EXTRACT FROM COUNCIL MEETING MINUTES OF MAY 27, 2014

SITE DEVELOPMENT FILE DA.13.105 REGIONAL MUNICIPALITY OF YORK WARD 4 – VICINITY OF MILLWAY AVENUE AND REGIONAL ROAD 7

COMMITTEE OF THE WHOLE MAY 13, 2014

SITE DEVELOPMENT FILE DA.13.105 REGIONAL MUNICIPALITY OF YORK WARD 4 – VICINITY OF MILLWAY AVENUE AND REGIONAL ROAD 7

Site Plan

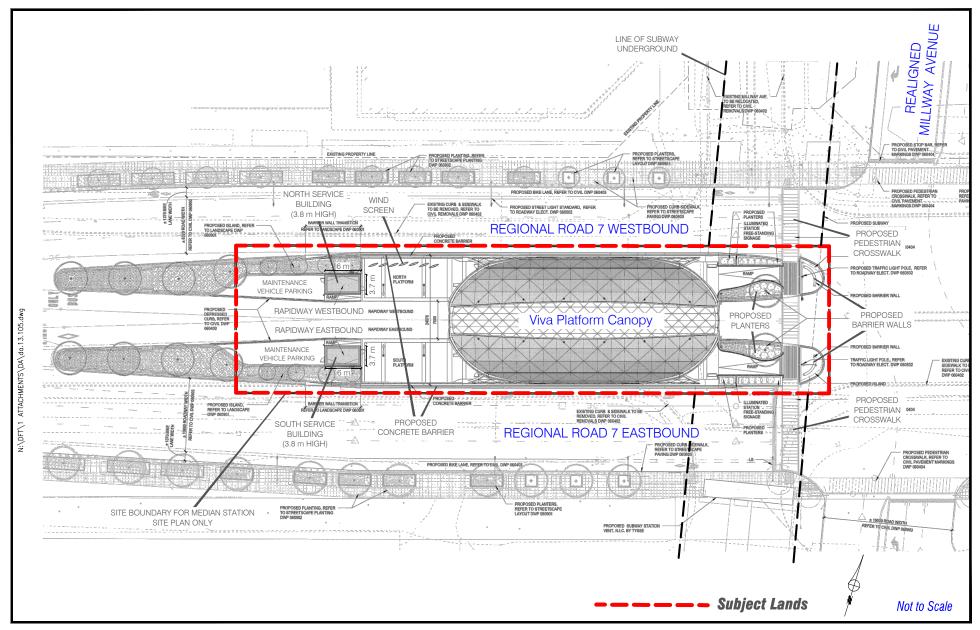
The proposed median station is serviced by two 3.8 m high maintenance buildings located at both the north and south platforms, shown on Attachment #3. The station is situated above an underground tunnel link from the VMC Subway Station that is currently under construction by the TTC (Toronto York Spadina Subway Expansion or TYSSE) and is part of a larger transit hub. Direct pedestrian access from the median station platform to the VMC Subway Station will be from 2 escalators, 2 stairways, and 2 elevators, as shown on Attachment #8.

- <u>Response</u>: The service buildings have been reconfigured from a 6 m by 6 m square shape to a 6 m by 3.7 m rectangular shape, thereby minimizing visual impacts, but allows for the functional operations of the station.
